Re: Haldimand County Hydro Inc.
Comments on Draft Conditions of Approval
Board File No: EB-2011-0027

We are counsel to Haldimand County Hydro Inc. ("HCHI") in this proceeding and are responding to a request for comments on the Draft Conditions of Approval issued by the Board on September 20, 2011.

CROSS SECTION "A" CONCESSION ROAD 5

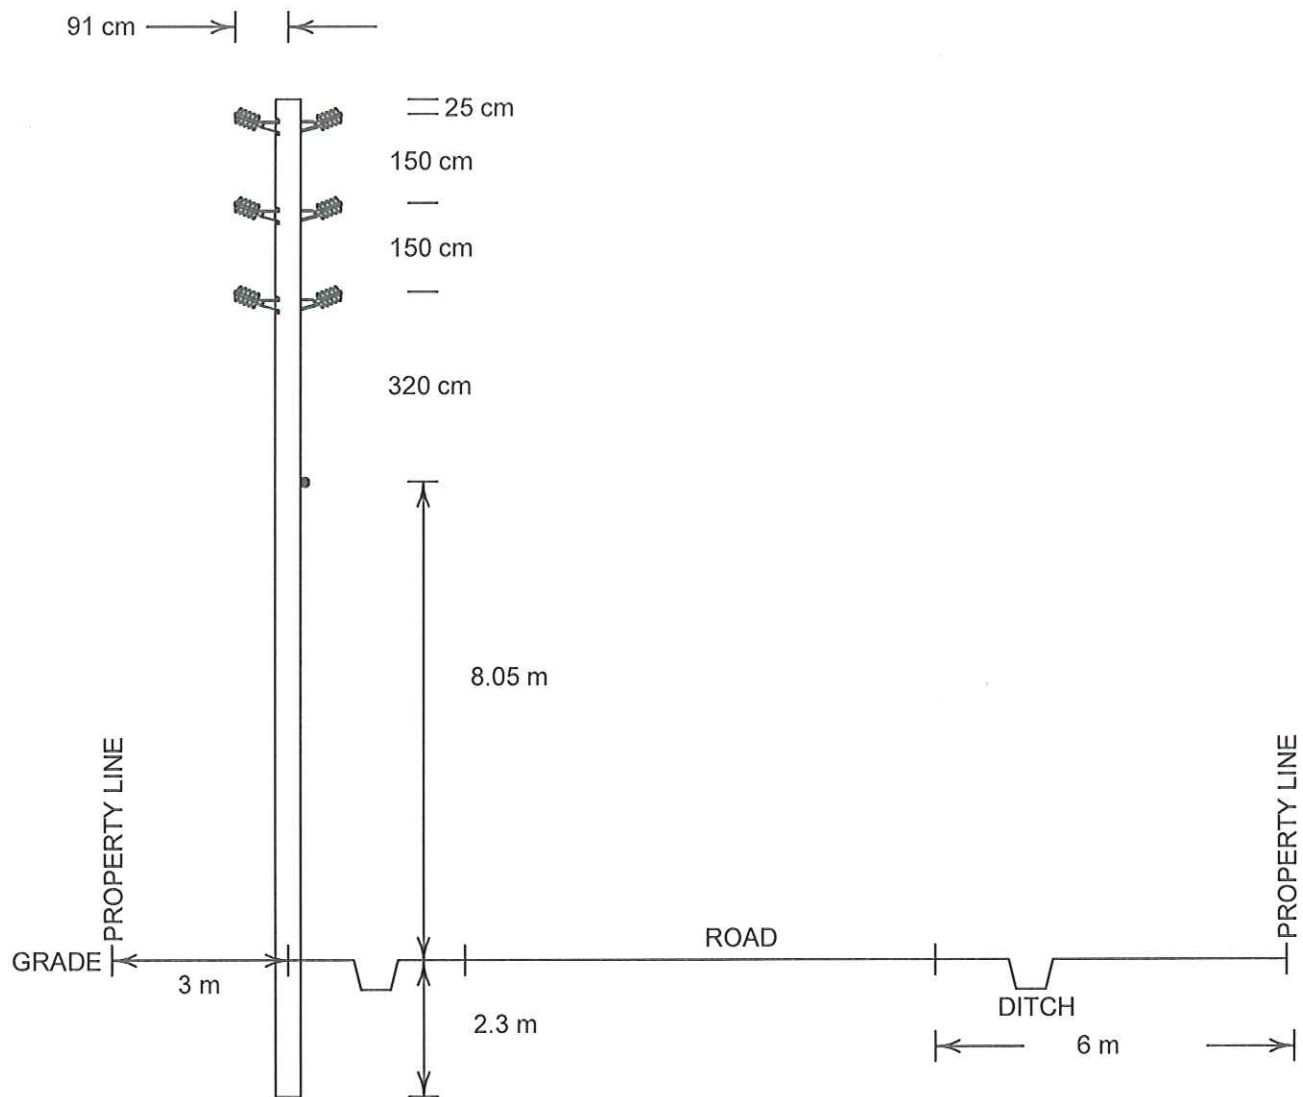
With respect to condition 2.3, HCHI would suggest using a 5 metre distance from the south property line of the Concession Road 5 right of way and removing the reference to the 6.3 metre separation from the HCHI proposed upgrades.

Condition 2.5 – HCHI does not agree with the proposed change from 10 metres to 5 metres. The 10 metre distance was an appropriately conservative approach recommended by Kinectrics. If the Board amends Condition 2.3 as suggested above it will serve to minimize the required offset of the poles.

CROSS SECTION "C" CONCESSION ROAD 4

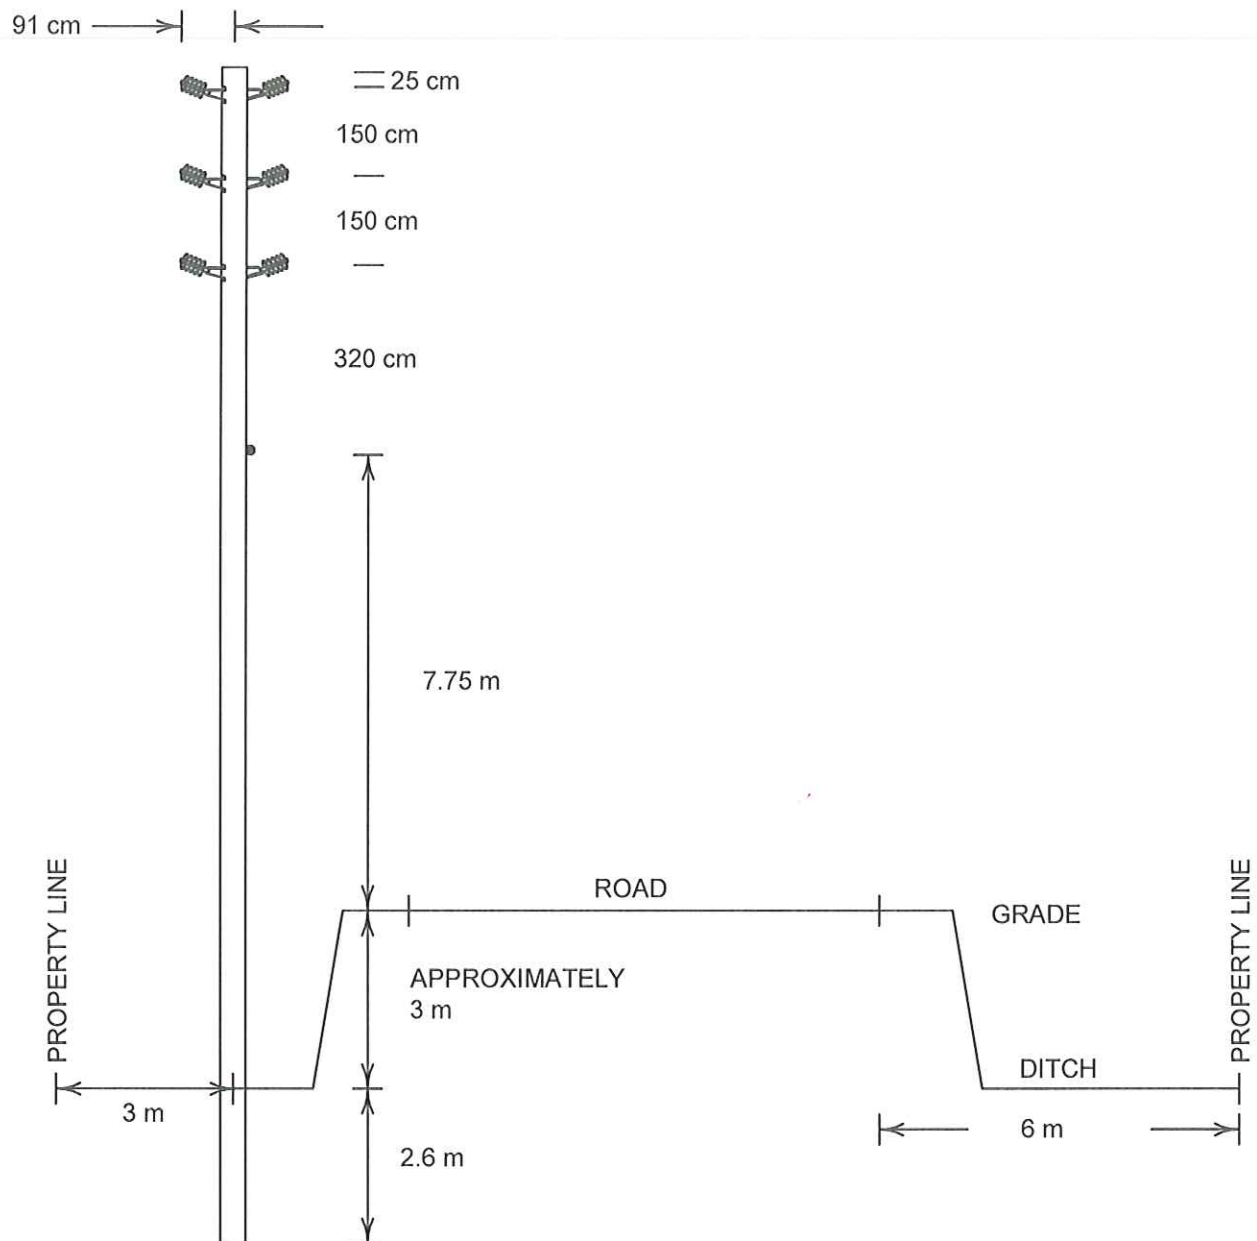
Condition 2.4 – We understand that certain environmental permitting requirements may limit the Applicant's installation options where the Transmission Line crosses Concession Road 4. In the unlikely event that a situation arose where environmental permitting resulted in the installation of the Transmission Line in such a configuration that HCHI was required to install the 27.6kV circuit underground to achieve code compliance, HCHI would submit that the Applicant should bear the incremental cost of an underground installation.
